CITY OF ALLENTOWN HISTORICAL ARCHITECTURAL REVIEW BOARD FINAL REVIEW SHEET MAY 2, 2016

Case #HDC-2016-00004 Proposal to maintain the secure, wood full light door installed on side of building.

Property located at: 347 N 8th Street Historic District: Old Allentown Case #HDC-2016-00004

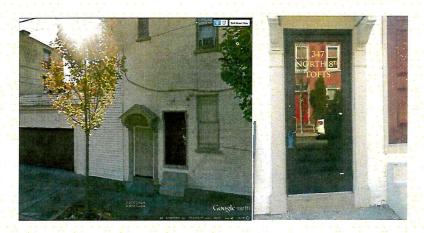
Proposed alterations: It is proposed to maintain the secure, wood full light door installed on side of building. This door replaced a pressed metal non-original door.

Repairs, Replacement and Alternate Materials; 6 Doors **Evaluation, effect on historic district, recommendations**: The new full light wood door is historically appropriate and more historically appropriate than the previous existing 6 panel door. The

Discussion: The applicant said he now understood the HARB process and would be sure to follow before doing work. Mr. Fillman disclosed his previous contact with the applicant, and clarified what he had said and not said to the applicant. The need to have the side as well as the front and any other part of the building visible from a public right-of-way reviewed was repeated. Mr. Fillman and the other members of the HARB agreed that the new door installed was historically appropriate and better than the previously existing door.

- 1. The proposal to maintain the secure, metal full light door installed on side of building at 347 N. 8th Street was presented by Alex Wright.
- The proposed work was approved as submitted and installed.
- 3. Work on all visible sides of the building needs to be reviewed prior to work being completed in the future.
- 4. The proposal to recommend a COA was unanimously approved. (5-0; motion carried; *Berner, Fillman, Huber, Jackson, Sell*)
